RE: *Nevada Division of Environmental Protection (NDEP) Response to: Technical Memorandum: Schedule for Stained Area Confirmation Sampling, Tronox Henderson Remediation Project, Henderson, Nevada, dated February 4, 2011*

VISUALLY IMPACTED AREAS SUBJECT TO CONFIRMATION SAMPLING		
Tronox LLC Henderson, Nevada		
SCALE: 1 in = 500 ft	DATE: 02/04/2011	PROJECT NUMBER: 2027.07 T21

SHEET NUMBER	1
FIGURE NUMBER	1

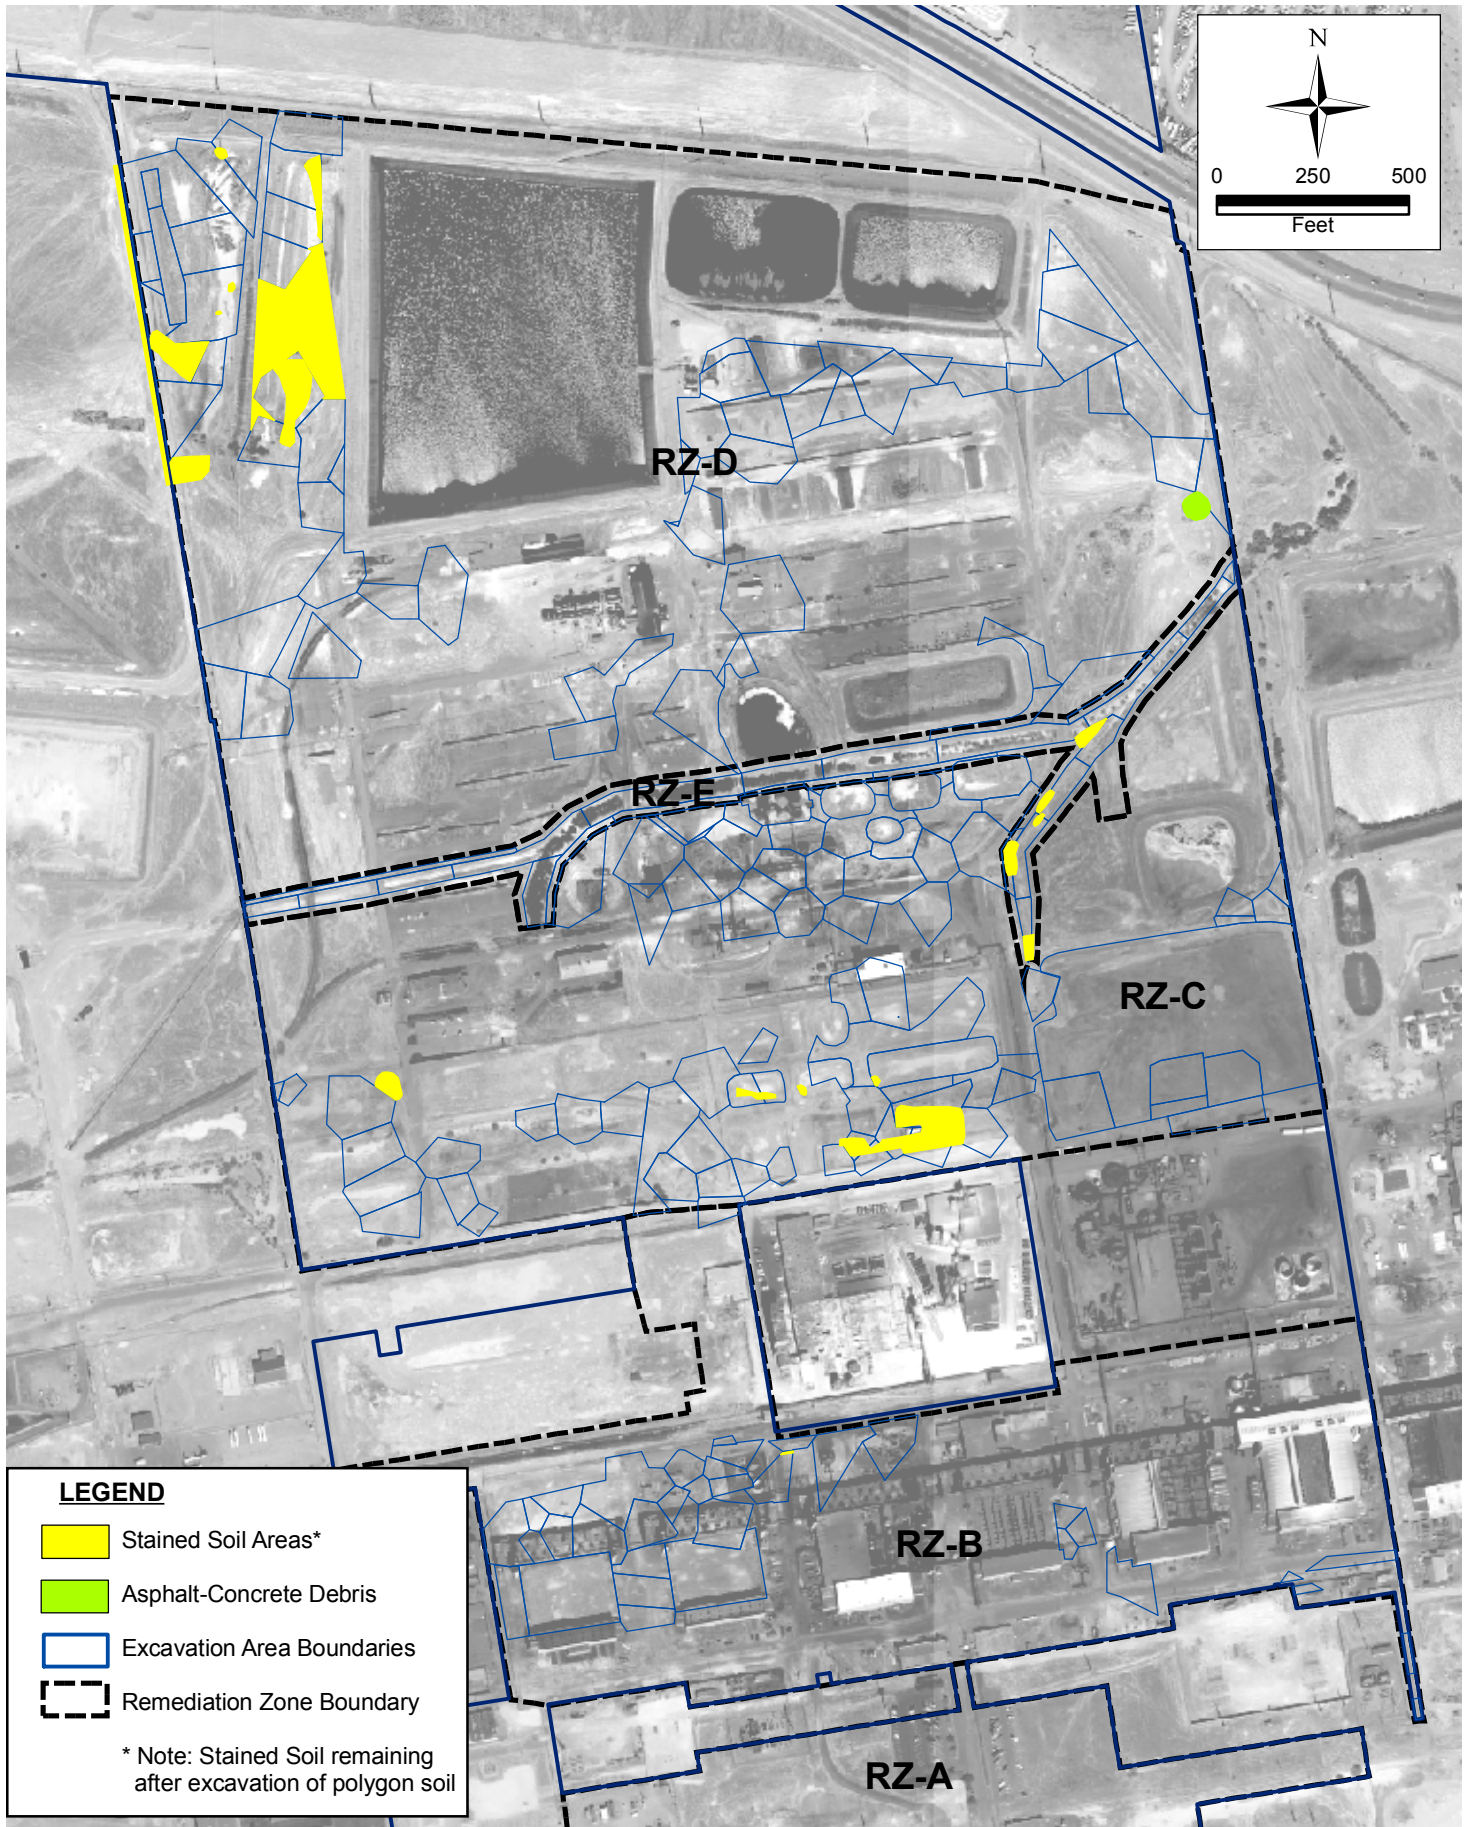
1. *TRX should submit a revised Figure 1 that shows the location of the visually impacted soil on the property boundaries and in RZ-D-25A.*

RESPONSE: Please see the attached revised Figure 1, which has been revised to show the location of stained soil observed in the vertical cut at the western property line in the northwest corner of RZ-D and the area where asphalt concrete debris was found in RZ-D-25, as well as a newly identified area of stained soil located at the end of the southeasterly extension of RZ-E.
